# Broadmeadow East Mine Environmental Authority Amendment Application – Supporting Document

## Bowen Coking Coal Limited

Revision: 0.2

26 July 2024

Figure 4.4 Updated Groundwater Monitoring Network

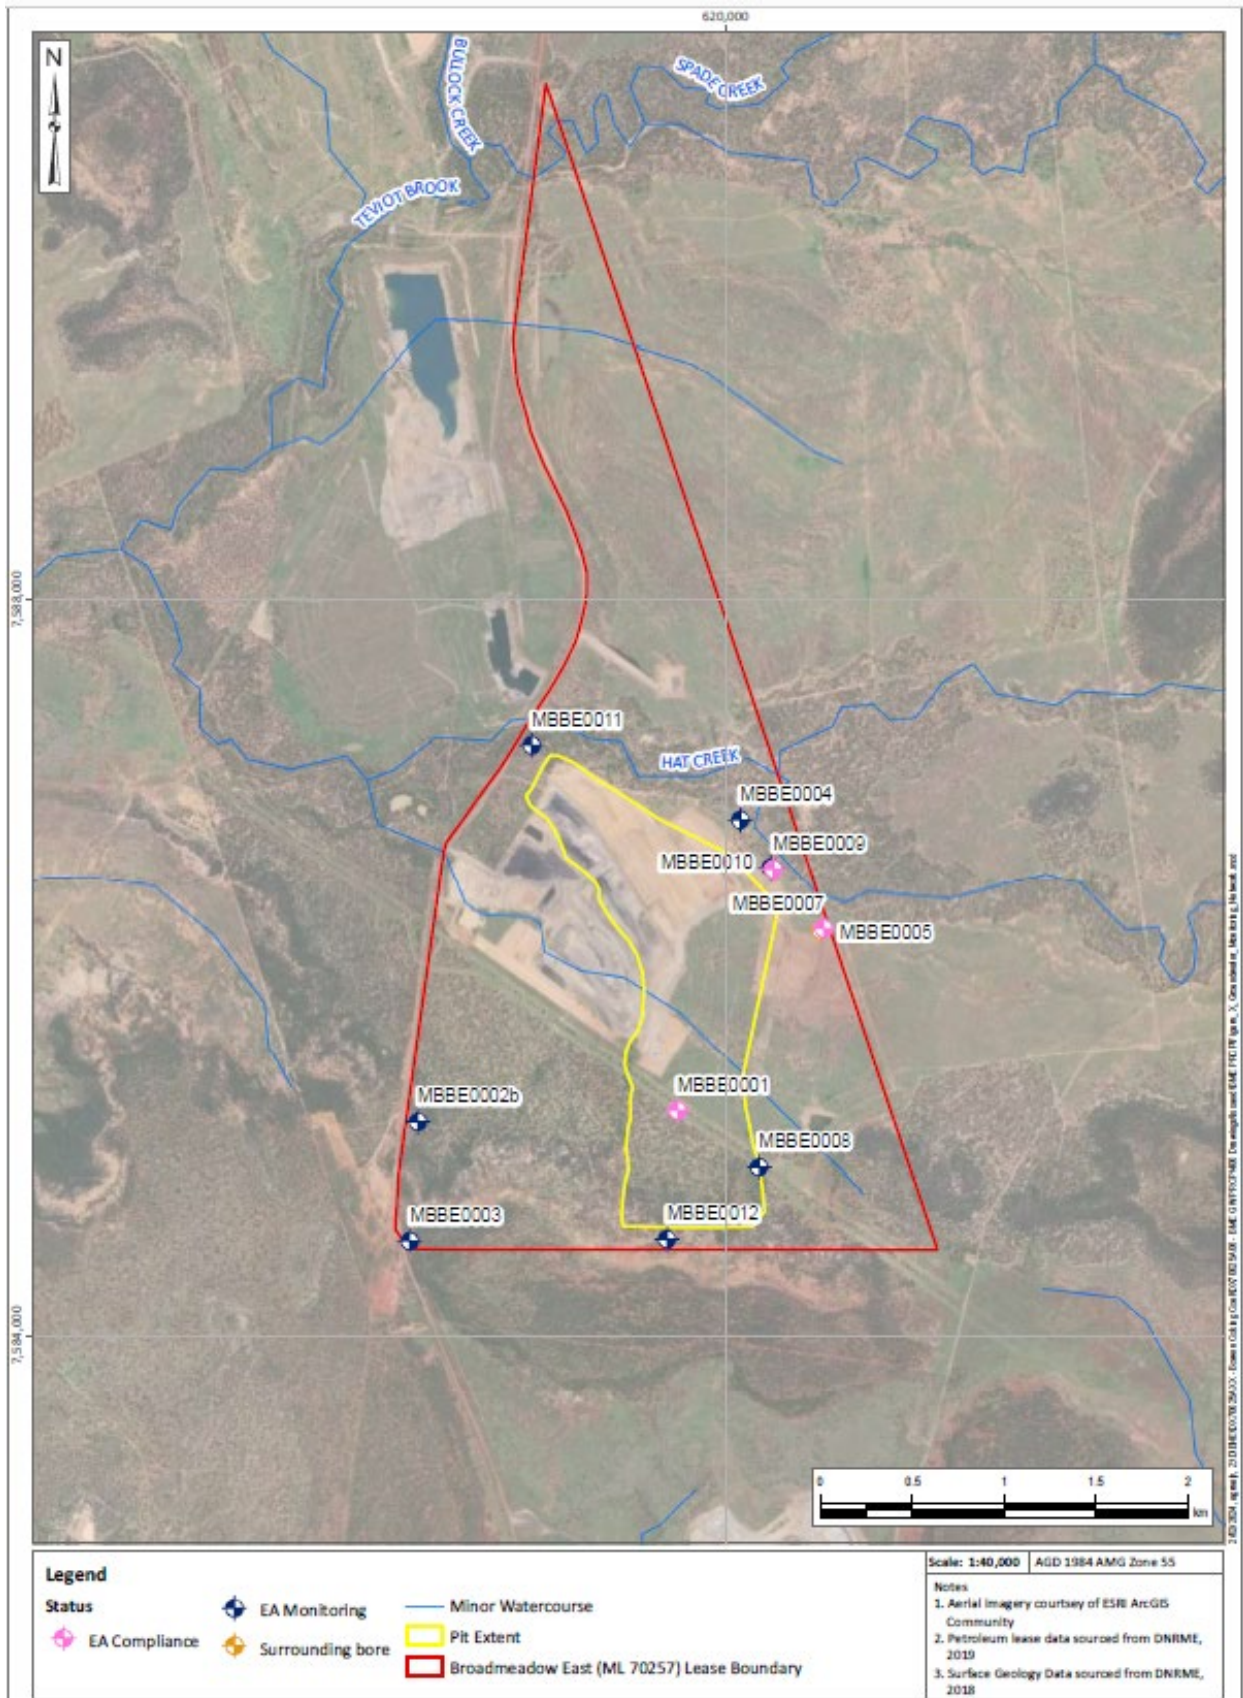
The updated location of groundwater bores is shown in Figure 4-4.

Figure 5.8 Final landform design

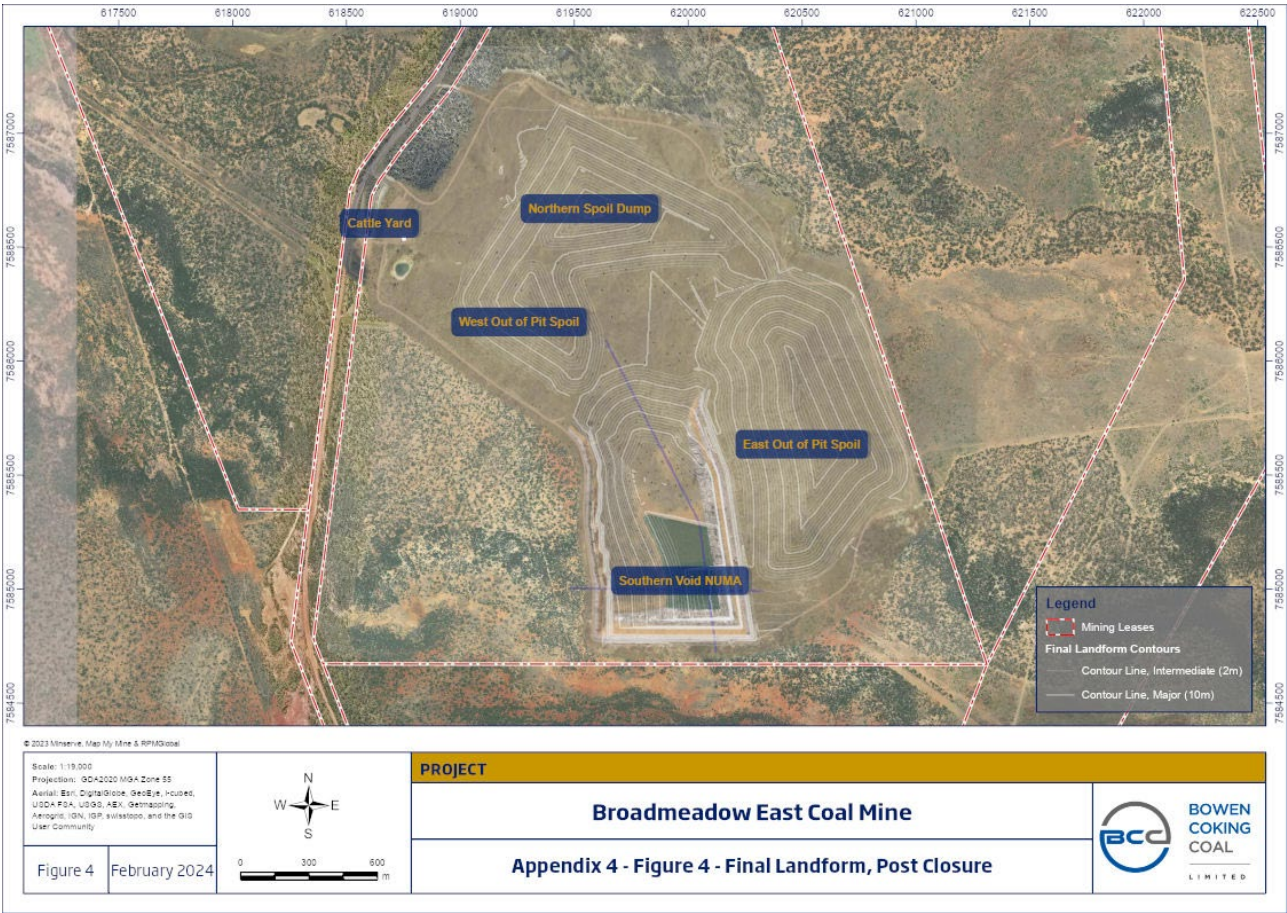
The final landform design for the Project is shown in Figure 5-8. It is proposed that this figure replace *Appendix 4 Figure 4 - Final Landform* in the EA (refer Section 8.1.4). As described throughout the PRCP (RPM Global, 2023a), the final landform consists of two out of pit dumps that closely border a predominantly backfilled pit to pre-mining topography with a Southern Void remaining in the location that mining ceases.

Existing Figure in EA

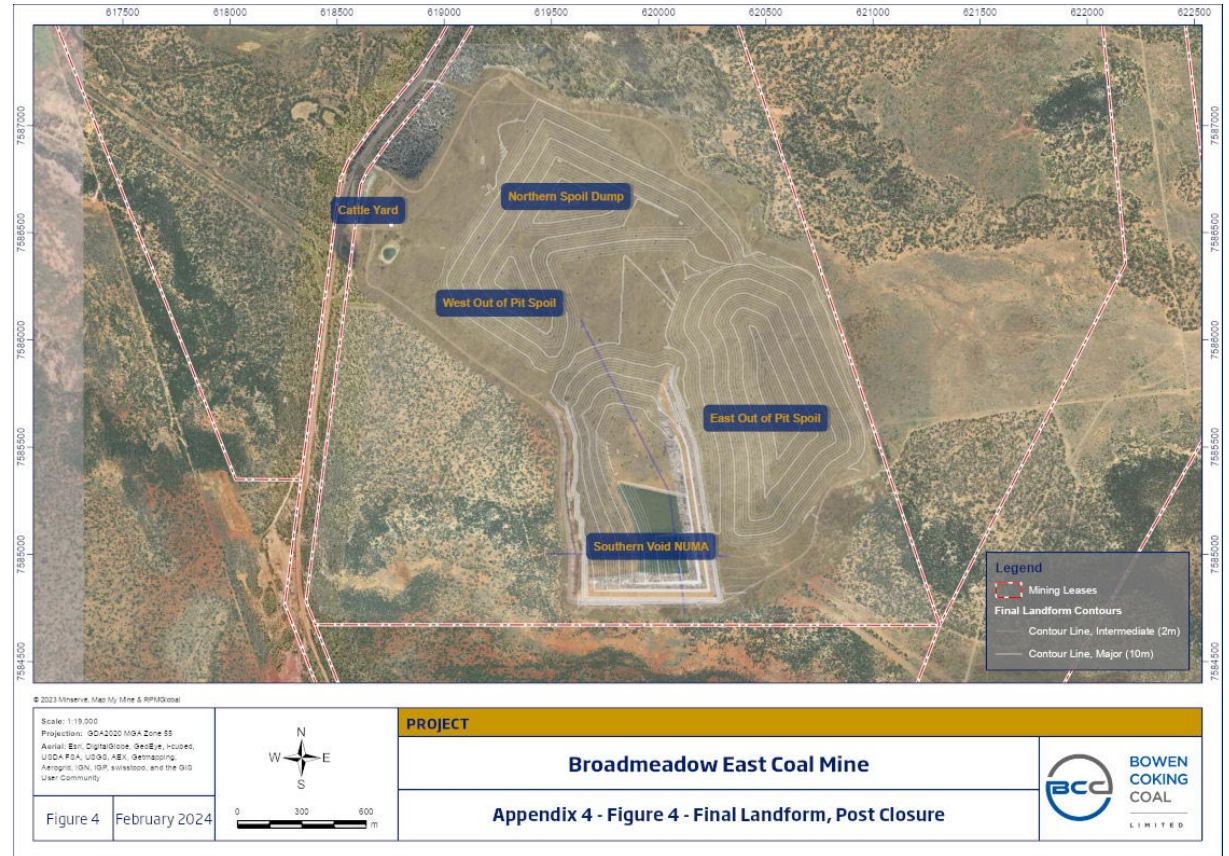
## 8.1.4 Appendix 4 Figure 4 – Final landform, post closure

Proposed New Figure in EA
